Summary Report

Polk Parkway (SR 570) Painting of Bridges 160257, 160258, and 164507
Financial Project No. 431123-1-52-01
Contract E8N37

Polk Parkway (SR 570) Painting of Bridges 160257, 160258, and 164507

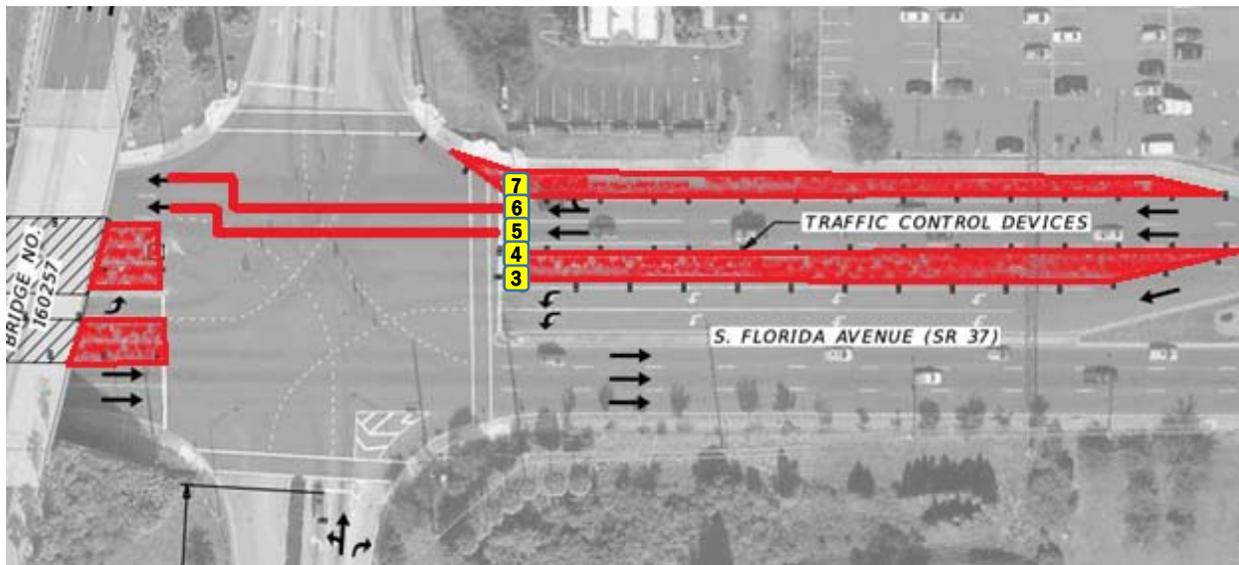
During TCP Phase 1, traffic traveling southbound on Florida Avenue in Lane 7 (image below) had the option to turn right to go eastbound on North Parkway Frontage Road or continue straight below the bridge. The MOT plans appeared to assume Lane 7 was a right-turn only lane. No signage established Lane 7 as a 'Right Turn Only' movement. If this plan was implemented, SB traffic in Lane 7 would enter the work zone.

The CEI staff directed the Contractor to close Lane 7 along with the specified Lane 6 closure. Drivers turning right onto North Parkway Frontage Road did so from Lane 5. CEI contacted the EOR the next day to inform her of this issue and confirmed the acceptability of the change.
